## Report to Sydney Central City Planning Panel

<b>SWCCP reference</b>	2018SWC047
<b>DA No.</b>	DA/875/2017
<b>Date of receipt</b>	09-Oct-2017
<b>Proposal</b>	Section 4.55(1A) modification to amend the approved sea wall design
<b>Street address</b>	7-11 Burroway Road – Wentworth Point
<b>Property Description</b>	Lot 204 in DP 1216628
<b>Applicant</b>	Roads and Maritime Services
<b>Owner</b>	Roads and Maritime Services
<b>Submissions</b>	Nil
<b>List of All Relevant s79C(1)(a) Matters</b>	<ul style="list-style-type: none"> <li>• Environmental Planning and Assessment Act and Regulations</li> <li>• State Environmental Planning Policy No. 55</li> <li>• NSW Coastal Management SEPP</li> <li>• State Regional Environmental Planning Policy (Sydney Harbour Catchment) 2005</li> <li>• Sydney Regional Environmental Planning Policy No. 24 (Homebush Bay Area)</li> <li>• Auburn Local Environmental Plan 2010</li> <li>• Wentworth Point Precinct DCP 2014</li> </ul>

# ASSESSMENT REPORT – SECTION 4.55 MODIFICATION

Extract from stamped approved plan (SK90) indicating mark-up boardwalk

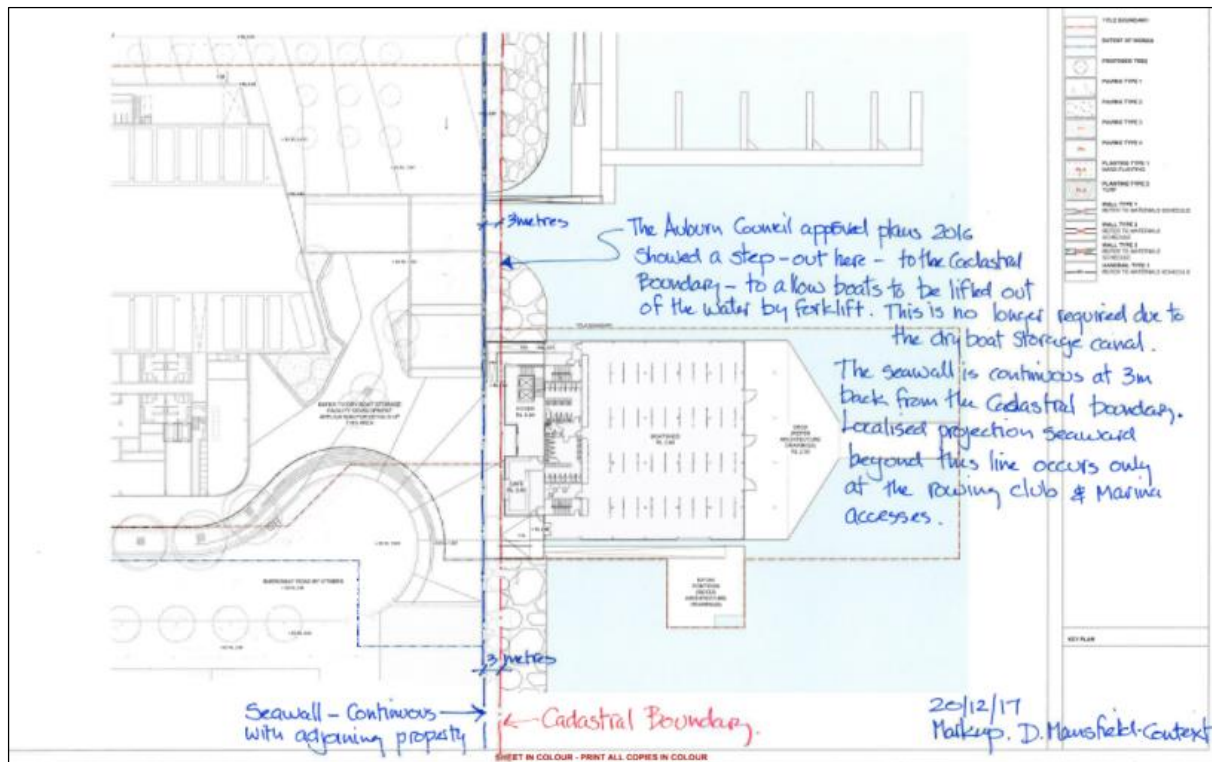
As part of the above application, approval was granted for the construction of a new seawall around the site adjoining the foreshore. One of the stamped plans (SK90) contains red mark-up changes requiring the extension of the promenade up to the MHWL indicating the provision of a boardwalk over the water for a length of approximately 50m.

The application seeks to amend the seawall design in terms of adjusting part of the promenade alignment over the seawall. The proposed modifications to the development consent seek to reverse changes made to the design of the Wentworth Point revetment by the consent authority at the time of approval (Auburn Council). These changes included a requirement for the promenade to extend over the proposed sloping rock seawall which was marked on the Stormwater Discharge Plan (Drawing reference 13308-SK90).

It is proposed that the original plan be approved without the mark-up on it. It is noted that the plans will still indicate a slight stepping out from the promenade over the seawall in part. A condition of consent will be imposed that now requires the continuous alignment of the seawall along this eastern foreshore promenade. This is a result of much resolution of the seawall and the adjoining promenade along the peninsula since the time of original approval. This is reflected within the following plan provided by the applicant.

- Prior to commencement of any works the detailed sea wall design shall be submitted to the City of Parramatta Council for approval.
  - **The seawall along the eastern boundary adjoining the promenade is to be designed in a continuous alignment in accordance with the Public Domain Alignment Plan L-1001 – Markup by D. Mansfield (Context) dated 20.12.2017 and is to align with the approved seawall on the adjoining southern property at 16 Burroway Road, Wentworth Point. The alignment is to match in terms of location and top of seawall levels as shown on development consent DA/674/2016, plan reference 20140163 Drawing DA102 Revision E dated 06.10.2017 prepared by Scott Carver.**
